# Monthly Specification Update

**Intel<sup>®</sup> Server Board S5000PAL**

*Intel Order Number D65289-033*

**April 2010**

### 63. Hard Disks Are Difficult to Install in Intel® Server System SR2500AL and Intel® Server Chassis SR2500

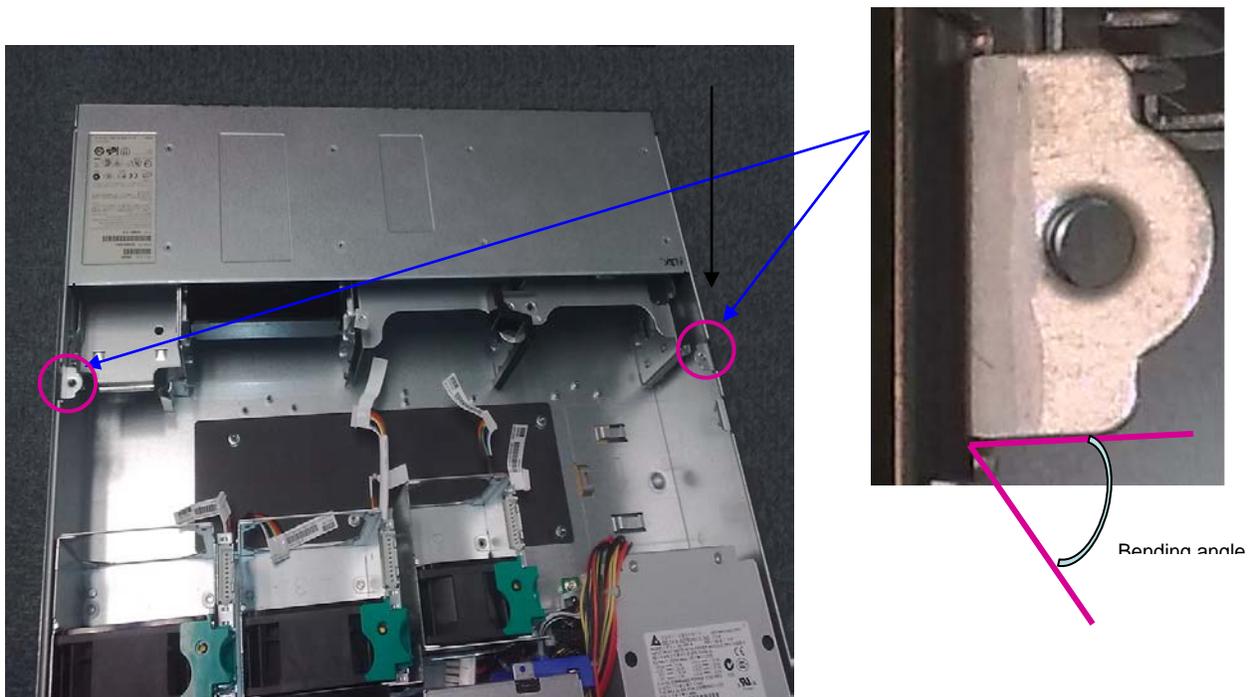
**Problem** Customers may find it difficult to properly and fully install the hard drives into the hard drive slots. This is because the backplane is about 0.5-1.5 mm vertically higher than the specification.

**Workaround** Check to ensure the bottom of the backplane touches the chassis base. If there is an obvious gap, check the two bending features (shown below) and make sure the bending angle is no more than 90 degrees. If necessary, use flat-nose pliers to bend these two features down to lower the backplane. Contact your local Intel Customer Service for more information.

## 1. The SMBUS block diagram (Figure #16) provided in Rev. 1.1 of the Intel® Server Board S5000PAL/S5000XAL TPS requires changes to accurately reflect production hardware design

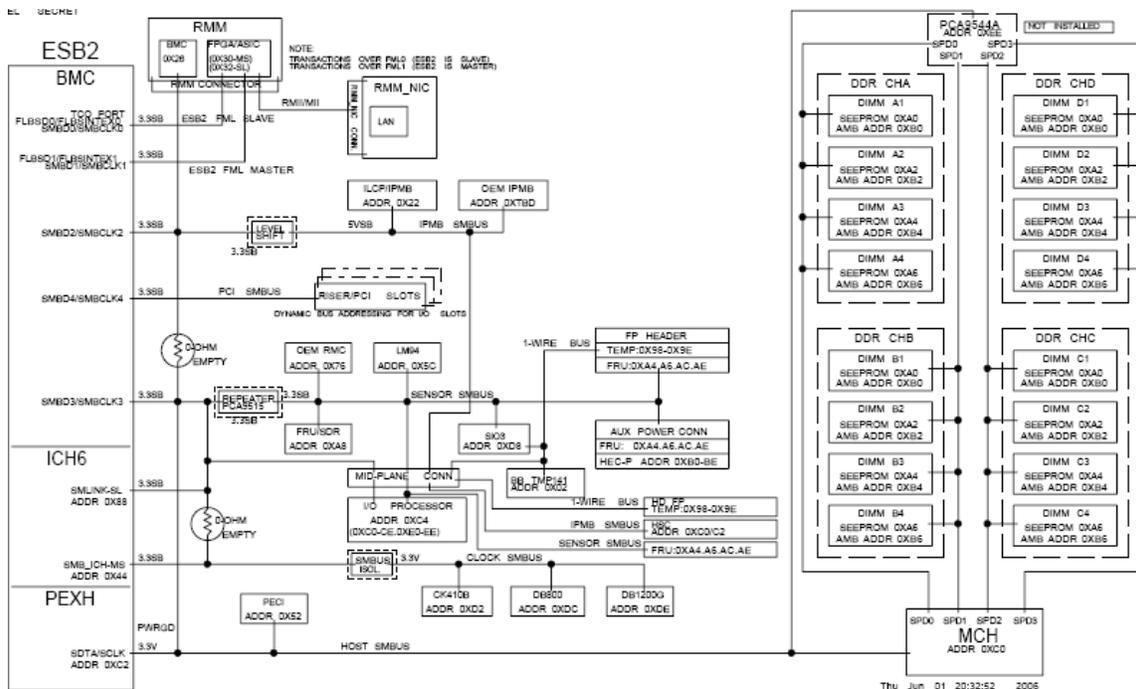
- Add PECI controller
- Remove separate HSC connector
- Correct Midplane -> FP SMBus connections and 1-wire temp sensor
- Correct SMBus and 1-wire temp sensor connections to FP connector
- Correct FBDIMM labeling

The corrected diagram is shown:

**2. The power block diagram (Figure #25) as provided in Rev. 1.1 of the Intel® Server Board S5000PAL/S5000XAL TPS does not reflect the final, production-level baseboard design**

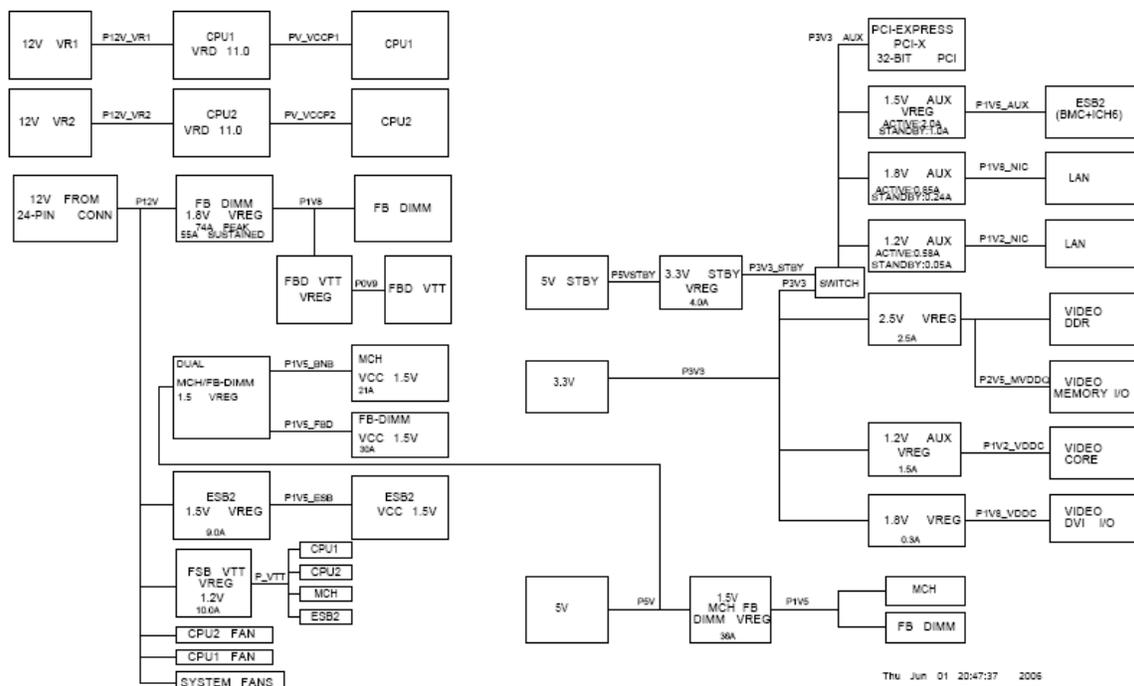
- MCH/FBDIMM 1.5 Vreg moved from 12 V rail to 5 V rail.
- Video Memory Vreg corrected to only one 2.5 V reg. instead of two.
- “ATI” label for Video components changed to generic “Video”.

The corrected diagram is shown:

Figure 22. SAS/SAS RAID Mid-plane Board

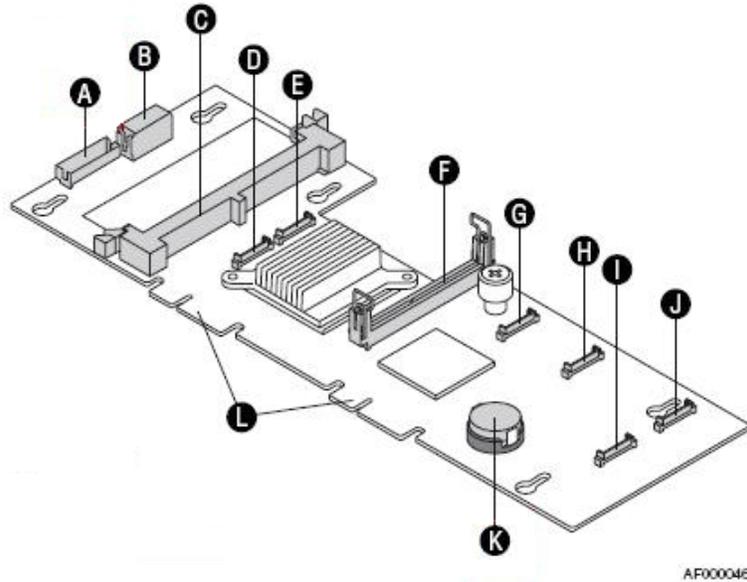
**3. SAS/SAS RAID midplane board (Figure #22) as provided in Rev.1.0 of the Intel<sup>®</sup> Server System SR2500AL TPS should swap the descriptions of items A and K**

Status: Corrections will be incorporated into the next version of the *Intel® Server System SR2500AL Technical Product Specification*.

#### 4. Front panel pin-out in the Intel® Server Board S5000PAL Quick Reference Label is incorrect

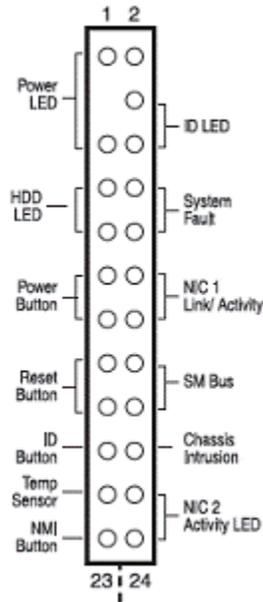
Problem: The current diagram incorrectly lists a cooling status pin, does not have the temperature sensor listed, and shows incorrect locations for the ID LED. The corrected diagram is shown:
